New Reactors Division

**Step 4 Assessment of Mechanical Engineering for the UK Advanced Boiling
Water Reactor**

Assessment Report: ONR-NR-AR-17-022
Revision 0
December 2017

Figure 3 ECCS Start up Sequence

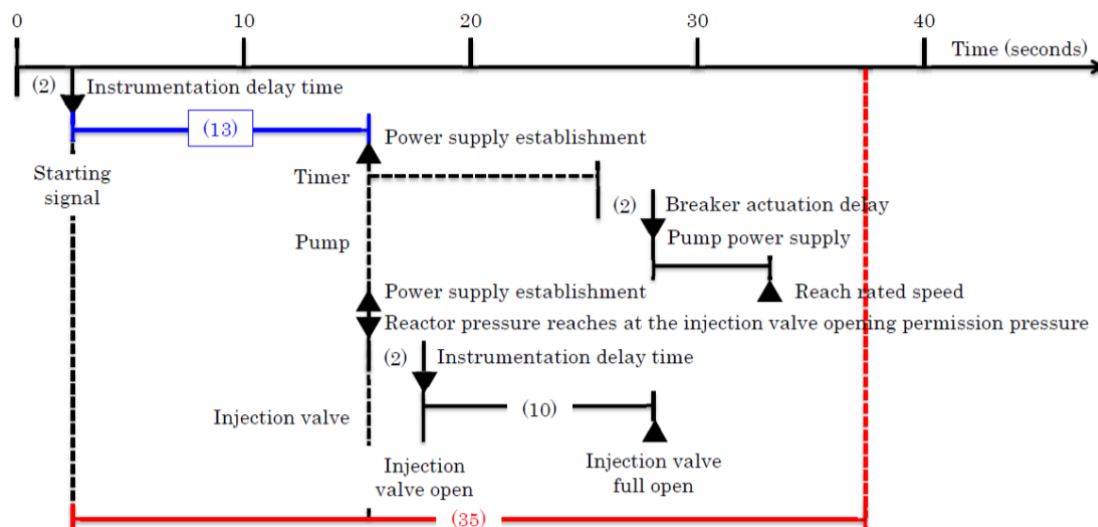
499. I queried the design basis and safety margins associated with the prescribed start up time for the diesel generators and Hitachi-GE's response is provided in [134]. The safety analysis for the Emergency Core Cooling System (ECCS) compares the delay time from receiving the LOOP signal to the start of the ECCS injecting coolant into the core. The start-up time of the emergency diesel generator (EDG) meets the safety requirement for the ECCS to deliver its safety function. The diagram below shows the ECCS start up sequence with the demands placed on the EDG in blue.

500. I consider the above to provide adequate justification for the EDG start up time.
